NORTHEAST NUCLEAR ENERGY COMPANY  
THE CONNECTICUT LIGHT AND POWER COMPANY  
THE WESTERN MASSACHUSETTS ELECTRIC COMPANY  
DOCKET NO. 50-336  
MILLSTONE NUCLEAR POWER STATION, UNIT NO. 2  
AMENDMENT TO FACILITY OPERATING LICENSE

Amendment No. 109  
License No. DPR-65

ATTACHMENT TO LICENSE AMENDMENT NO. 109

Replace the following pages of the Appendix A Technical Specifications with the enclosed pages. The revised pages are identified by amendment number and contain vertical lines indicating the area of change. The corresponding overleaf pages are provided to maintain document completeness.

FIGURE 3.9-1 MINIMUM REQUIRED FUEL ASSEMBLY EXPOSURE AS A FUNCTION OF INITIAL ENRICHMENT TO PERMIT STORAGE IN REGION 2

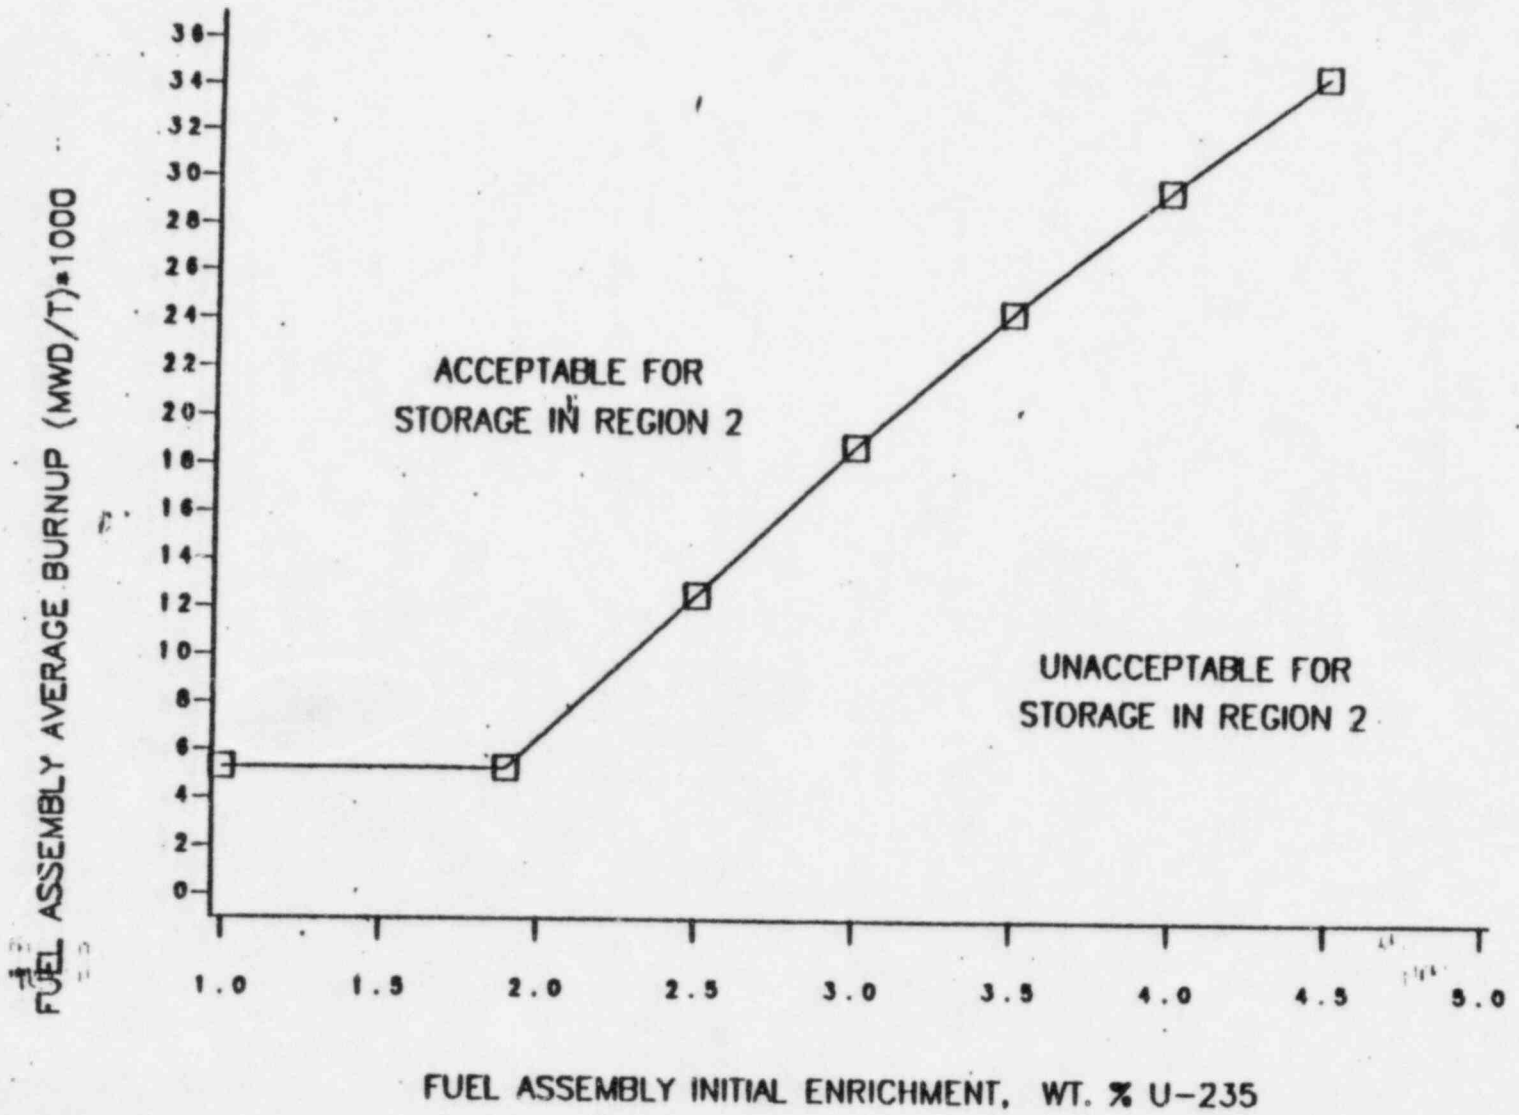
4.9.18 Ensure that all fuel assemblies to be placed in Region II (as shown in Figure 3.9-2) of the spent fuel pool are within the enrichment and burn-up limits of Figure 3.9.1 by checking the assembly's design and burn-up documentation.

The limitations described by Figure 3.9-1 ensure that the reactivity of fuel assemblies introduced into the Region II spent fuel racks are conservatively within the assumptions of the safety analysis.

c) Region II of the spent fuel storage pool is designed and shall be maintained with a 9.0 inch center to center distance between storage locations to ensure a  $K_{eff} \leq .95$  with the storage pool filled with unborated water. Fuel assemblies stored in this region must comply with Figure 3.9-1 to ensure that at least 85% of the design burn-up has been sustained.
